In accordance with the provisions of Section 320-21 (11) and (12) of the Milwaukee Code of Ordinances, the Milwaukee Historic Preservation Commission has issued a certificate of appropriateness for the work listed above. The work was found to be consistent with preservation guidelines. The following conditions apply to this certificate of appropriateness:

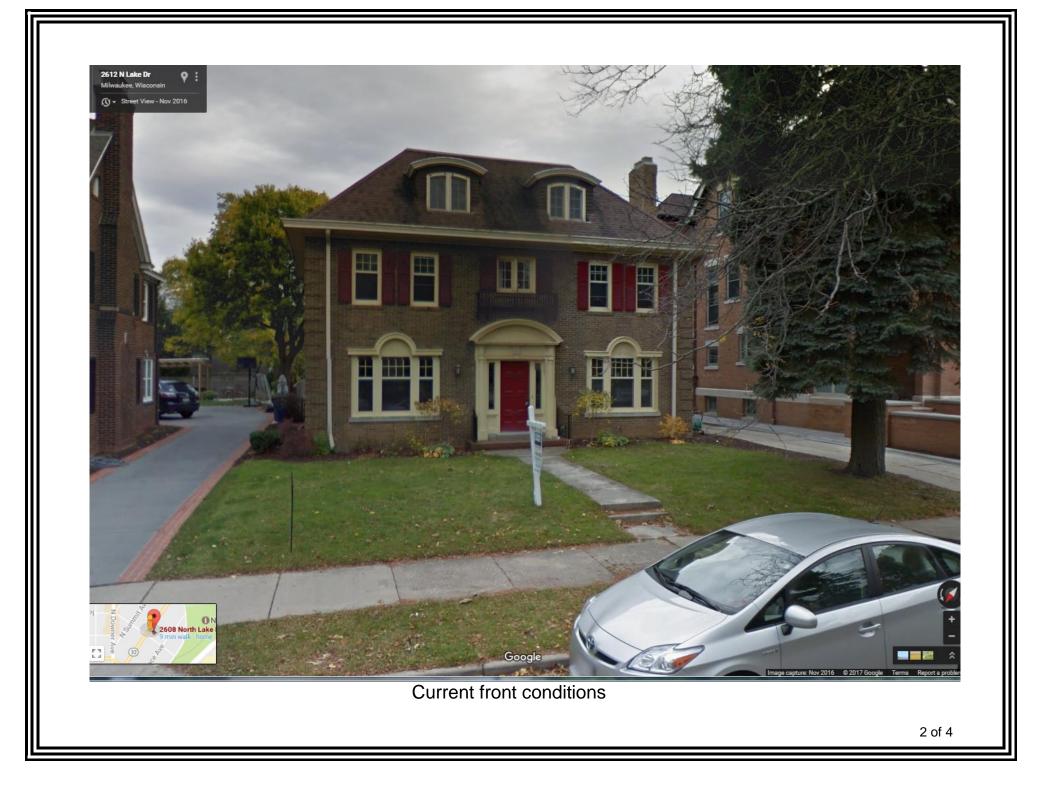
Installation location of heat pump in rear yard behind rear wing.

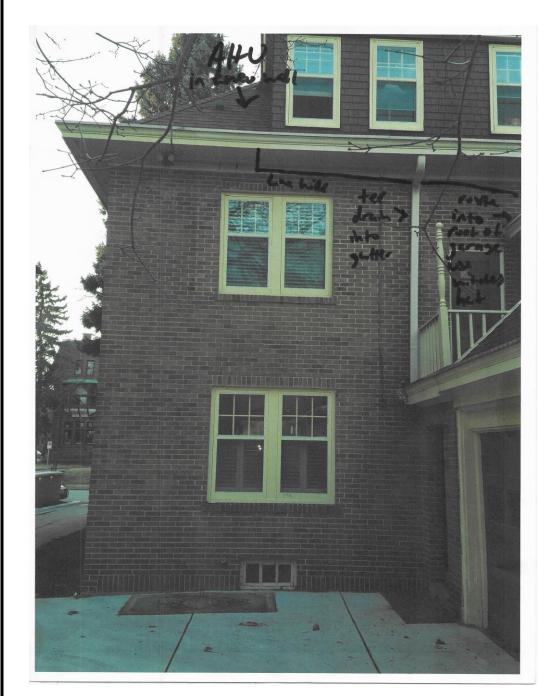
Drain piping locations on rear facades. Above gutter line, piping must be painted to match roof shingles. Below gutter line piping should be painted to match brickwork.
